DESIGN REVIEW COMMITTEE

August 3, 2017

FROM: NANCY FERBER, PLANNER

1. Design Review DR17-01 by Mike Stults, Cross Development, to construct a new 9,100 square foot commercial building at 2275 Commercial Street (Map T8N-R9W Section 8DA, Tax Lot(s) ~~1300, 1400~~, 1401, 1402, 1700, Lot(s) 4-6 1,2,4,5,6 (block 127), and associated portions of the vacated right of way and ~~1-4 (block 126)~~, within the Gateway and Greenway Overlay Zone in the LS, Local Service Development Zone. Development Code Standards specified in Sections 2.975-2.981, Article 9, 14, and Comprehensive Plan Sections CP.005 to CP.025, CP.057-CP.058, and CP.190-CP.210 are applicable to the request.

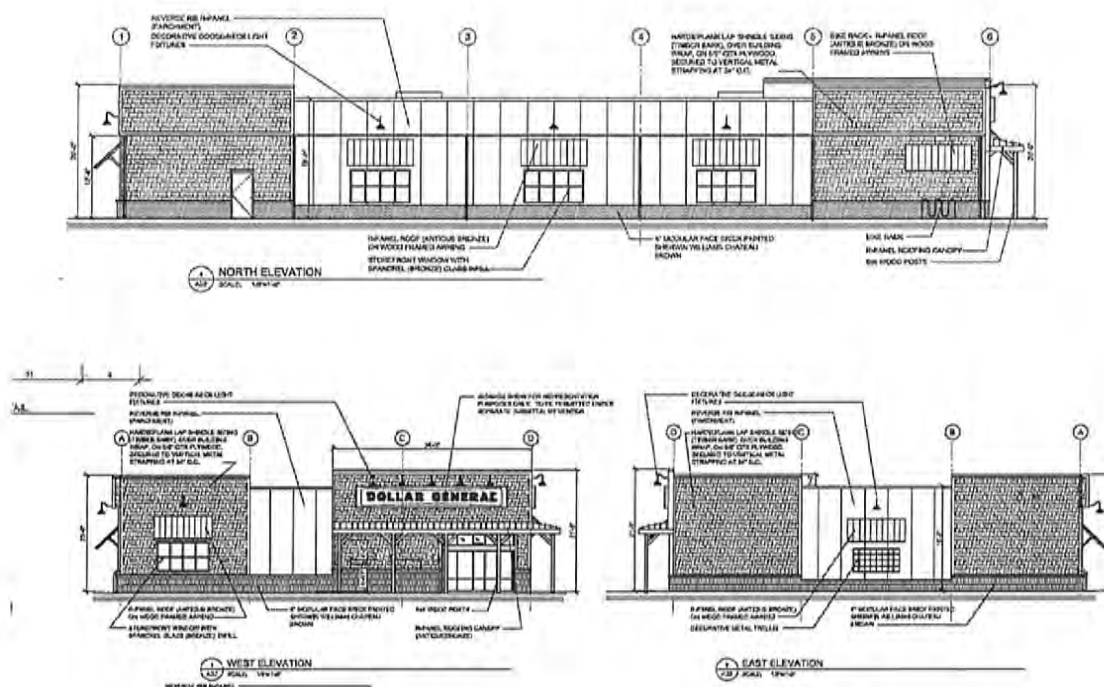
Finding: The proposed development is commercial structure, and at a single story is low in form, which is an encouraged building type. The new building is simple with a general square plan shape, and offset at the entry corner to help identify the building entrance. It is neither complex nor sprawling. However, it is a corporate prototype as mentioned in the application narrative, and as such does not reflect design elements commonly found in the area.

Discouraged window types such as spandrel glass are incorporated. The proposed horizontal siding is an encouraged wall treatment, but wainscoting is unusual for this site. The parapet roofing does not match any of the surrounding roofing designs or pitches. **Examples of adjacent property designs are show in Exhibit 3.** The proposed building elevations are below.

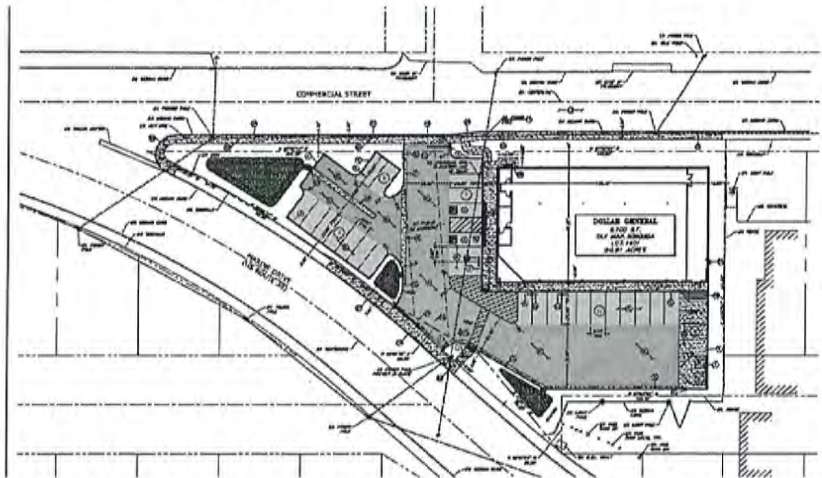
The fixed wooden canopy for rain protection and ease of customer entry is encouraged in commercial buildings. However, the proposed project will have an awning with exposed beams that have a southwestern design flair and are out of place in the Gateway area located near the waterfront and general gateway into the area. The use of wood is encouraged, especially in this location which is near the historic wooden mill that once operated near the site. However, the design of the awning needs to be altered to attach to the structure with visible supports similar to others in the Gateway area. Examples of other awnings appropriate for the area are below:

This guideline is not met.

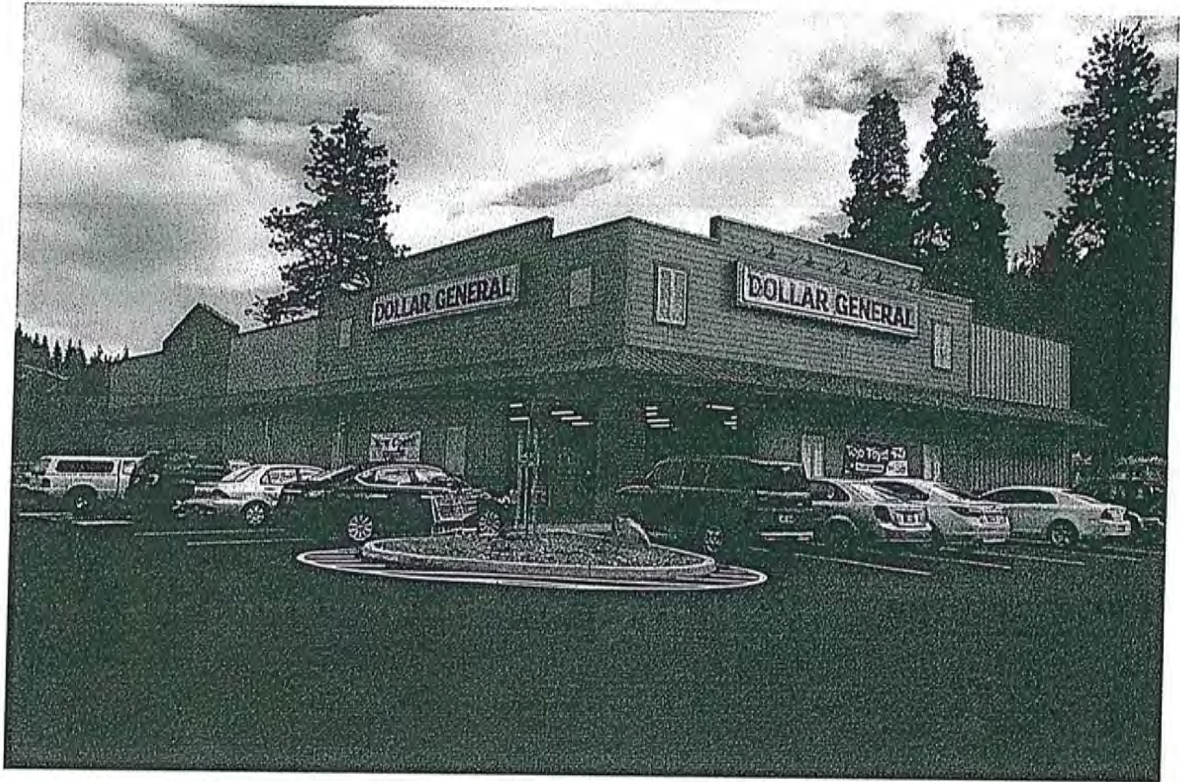
- The City considers the South Elevation (ref below) too much of a long-empty wall (not enough breakout/materials/etc.). The City would like for us to be more creative in applying building elements implied in both the City Design Guidelines. We also need to photograph and implement design elements used by other nearby buildings. The City advised that we consider the Pavillion (photo attached) as a reference.
 - We revised our footprint to a Corner Entry version of the prototype. This option allows us to face the pedestrian thoroughfare (Marine Drive). We are showing a long canopy over the entry element, with 6x6 wood posts. There are also decorative canopies over storefront window (with spandrel glass), a brick base, Hardiplank lap siding (shaker shingle type siding- see attached product picture), and Reverse Rib R-Panel siding.

- The use of Timber as a building feature was recommended.
 - 6x6 wood posts at long entry canopy, wood frame awnings.
- The City would like a different type of roof, but understands our limitations. They are asking for our creativity.
 - We have added parapet on all four sides of the building, so the roof is not visible.
- Need details on the Bike Rack.
 - We have added a bike rack to the North elevation with a canopy over that area. I have attached a cutsheet (7 Bike version). on for review.
- Use of Brick-Pavers for pedestrian route off Marine would help "pedestrian friendly". Need details on what we would submit.
 - The Site Plan is being updated, and will include a more 'pedestrian friendly' route. The attached Site Plan is NOT completed, but only show for Corner-Entry access.
